**Ordinary Council Meeting**

18 July 2019

8.1 DA10.2018.130.1 - Modification to Extractive Industry (Bombala Boral Quarry) Increase Maximum Production Volume from 100,000 Tonnes Per Annum to
200,000 Tonnes Per Annum

8.3		3 - Modification of a Subdivision for 62 Residential Lots at Cooma - Remove Condition 32	1
	Attachment 1	Advice from RMS	444
	Attachment 2	Council Correspondence to Applicant and Developer	446
	Attachment 3	Notice of Determination DA10.2016.543.2	448
	Attachment 4	RMS Referral Response	464
	Attachment 5	OCRE Engineer's Statement of Impacts	465
	Attachment 6	Letter to Minister - June 2018	468
	Attachment 7	Letter from Vision TP June 2018	471
	Attachment 8	Response to Vision TP - June 2018	476

Figure A 10: Warrants for turn treatments on the major road at unsignalised intersections

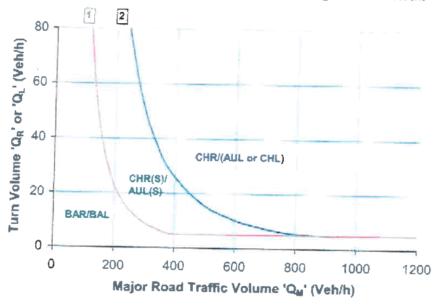
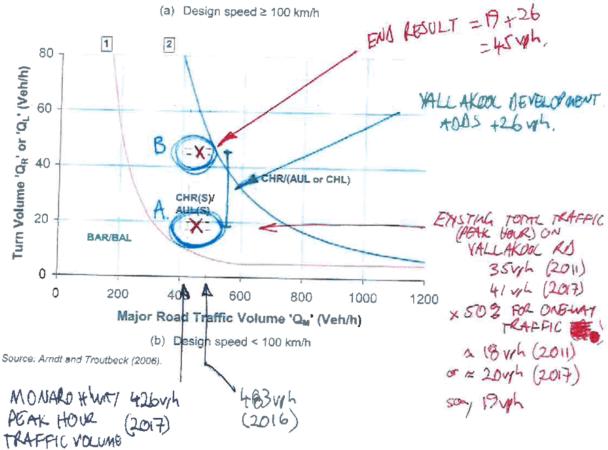
The extract from the RMS in the referred email, has confirmed that previous investigations of the traffic volume for the Monaro Highway used in the Warrants for turn treatment figures, have been understated, i.e. essentially half. Hence I have annotated Figure A10(b) with the corrected figures (see attached). The annotation of the figures illustrate that under current traffic figures (i.e. Qm – Monaro Hway Total Traffic (426vph (2017) or 483vph (2016) at the intersection, with an existing turn volume from the Highway into Yallakool Rd (18vph (2011) or 20vph (2017) say 19vph average), that the intersection is already above the threshold for a CHR(S)/AUL(S) type intersection (point "A"). Hence as the intersection exists at this time, without any traffic from any development on Yallakool Rd, the warrants suggest it is currently substandard.
